Re: Case: 15subdiv1003 Ball Homes Development on Factory

## 13605 & 13615 FACTORY LANE DEVELOPMENT REVIEW OF CONSERVATION SUBDIVISION PLAN

Planning and Design Services 15SUBDIV1003 Case Documents Permit Detail Data Portal Problem Comments, Various Agencies

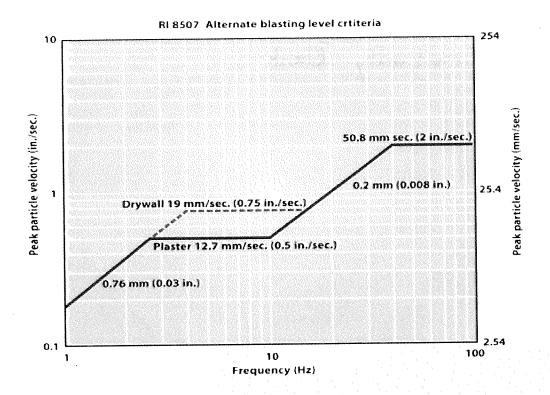
- 1. Provide a landscape buffer bordering LOT NUMBERS 96 84 that consists of the following:
  - a. Earth berm barrier running parallel to property line that is 10 ft. in height bordering the above-mentioned lots. Maximum side slope shall be 2:1. The earth berm should be constructed such that it provides an 8 ft. wide buffer strip atop the berm for plantings described in item (b). Provide a swale adjacent to lot number 96-84 property lines to appropriately direct and control storm water runoff. Also provide berm erosion control.

- b. The landscape buffer must provide a year round visual screen. Atop the earth berm provide a high density of clustered, diverse plantings including mature trees, shrubs and bushes to provide a visually opaque buffer. Plantings shall include deciduous trees and evergreens, along with shrubs between trees so as to provide ground cover. Rocks and boulders may also be used to enhance the landscape buffer. An example of an acceptable landscape buffer is shown in photos below (photos from The Falls on Old Henry). Trees of at least eight (8) ft. in height shall be produced within three (3) growing seasons. All plantings shall be installed according to accepted horticultural standards.

Note: as a minimum the earth berm and landscape buffer shall be provided bordering LOT NUMBERS 96-90.
